Work Order ID 150642

ENGINEERING CHANGE NOTICE NO.

DWG NO. 646.3300

DWG TITLE: UPPER CUTTER ASSY

SHEET 5 IS:

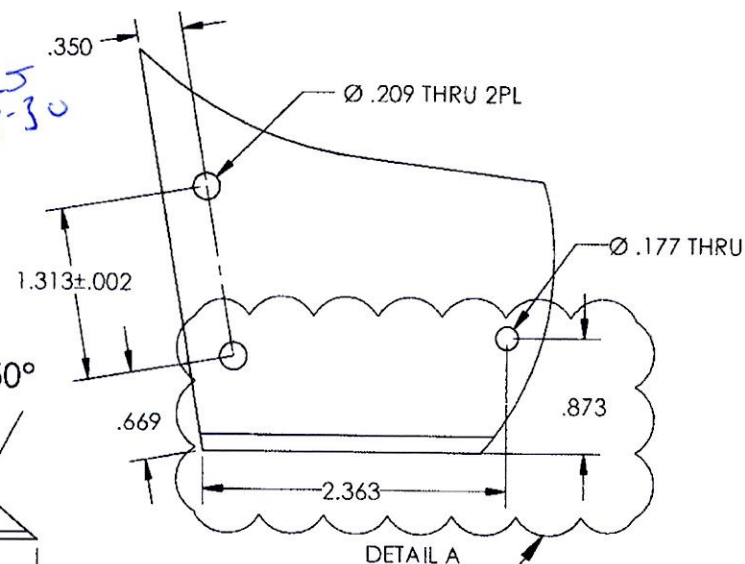
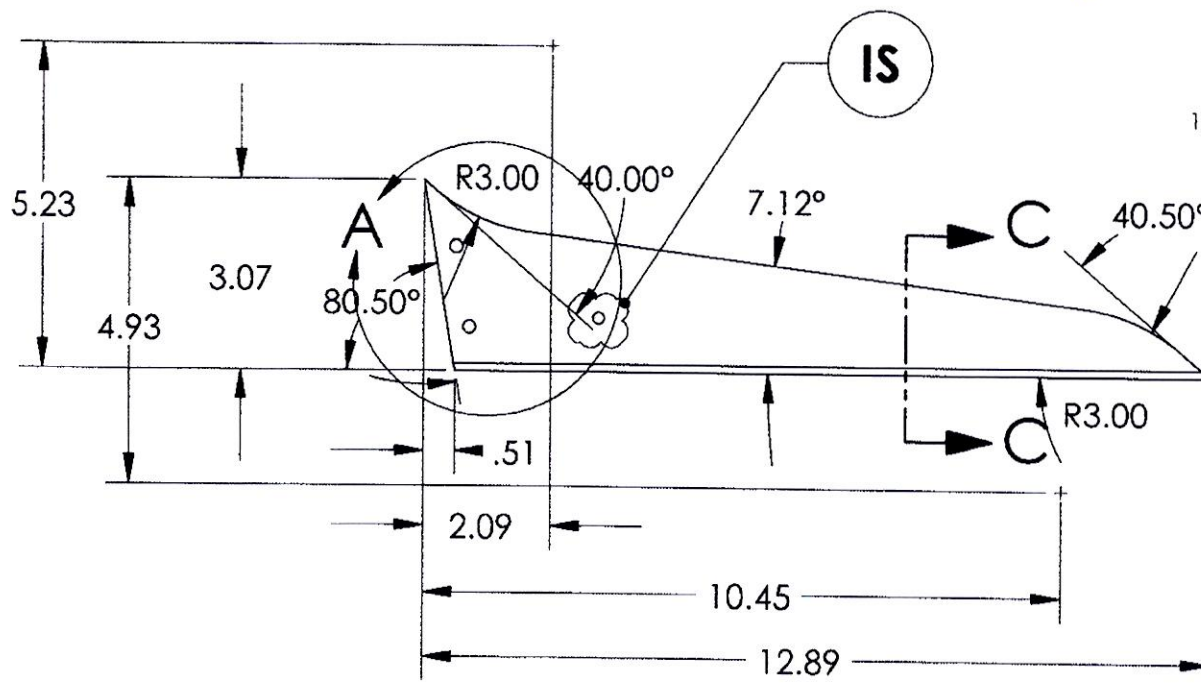
REASON: ADDED HOLE DIMENSION TO 646.3313.

SHEET 4, ZONE B8 IS:

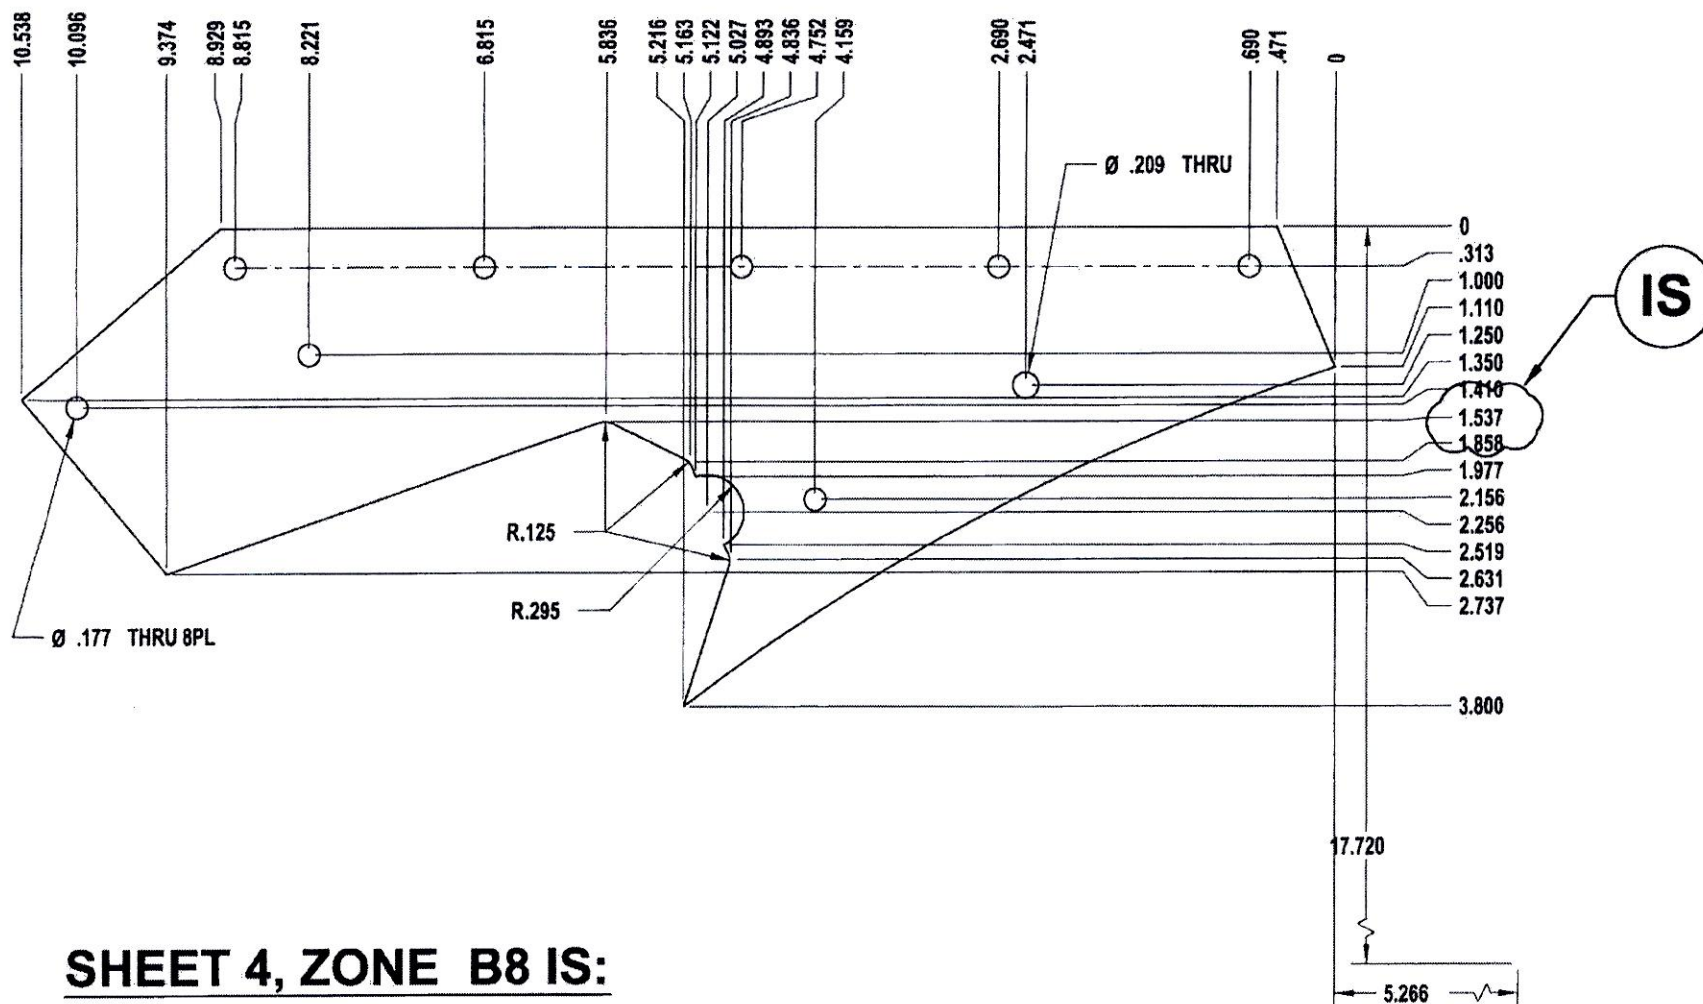
APICAL INDUSTRIES, INC.	ENGINEERING CHANGE NOTICE NO. 03724				SHEET 1 OF 1	
	DWG NO. 646.3300	REV: N/C	PREPARED BY B. PETERS	DATE: 12/05/12	EFFECT ON DWG ☐ INC. ☒ UNINC.	
	DWG TITLE: UPPER CUTTER ASSY					
APPROVED BY: ENGR <i>[Signature]</i>		MFG <i>[Signature]</i>		QC <i>[Signature]</i>	EFF: NEXT ORDER	
TRANSACTION CODES (TC) A-ADD C-CREATE R-REVISE D-DELETE		REASON: REVISED ORDINATE DIMENSION.				ECR: D-12-025

SHEET 1, VIEW 646.3301, IS:

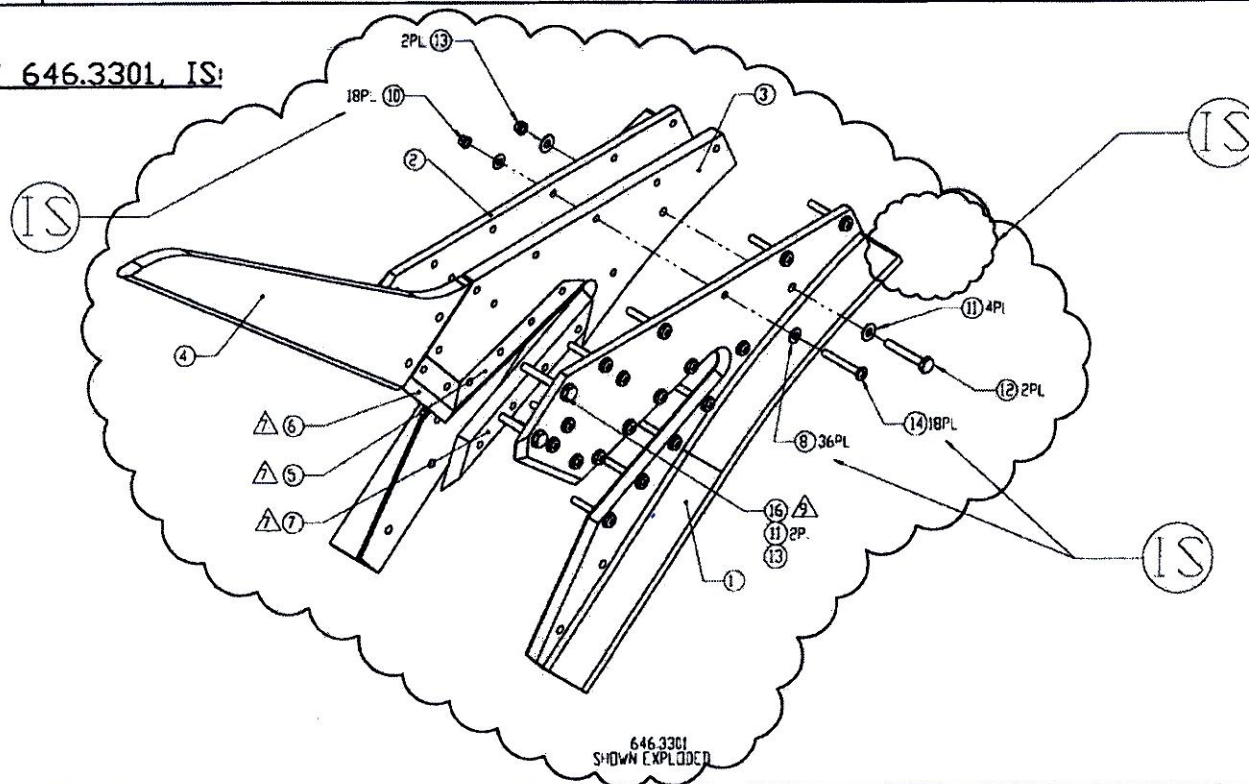
APICAL INDUSTRIES, INC.	ENGINEERING CHANGE NOTICE NO. 02196		SHEET 1 OF 2	
	DWG NO. 646.3300	REV: N/C	PREPARED BY S. HUFF	DATE: 01/05/09
	EFFECT ON DWG ☐ INC. ☒ UNINC.			
DWG TITLE: UPPER CUTTER ASSY				
APPROVED BY: ENGR <i>[Signature]</i>	MFG <i>[Signature]</i>	QC <i>[Signature]</i>	EFF:	NEXT ORDER
REASON: REMOVED RIVETS IN FAVOR OF ADDITIONAL SCREWS				
TRANSACTION CODES (TC): A-ADD C-CREATE R-REVISE D-DELETE

14	R	601.2765	18	SCREW	MS27039-0819
10	R	601.1541	18	LOCKNUT	MS21042L08
9	D	601.2766	3	RIVET	MS20470AD5-18
8	R	601.2764	36	WASHER	NAS1149FN832P
			3301		
F/N TC	PART NUMBER	QTY	DESCRIPTION	MATERIAL/SPECIFICATION	
DOCUMENTS EFFECTED:				CHANGE CATEGORY	DER REVIEW REQUIRED
☐ MDL ☒ INSTALL INSTRU ☒ ICA ☐ FMS ☒ BOM				☐ MAJOR ☒ MINOR	☐ YES ☒ NO
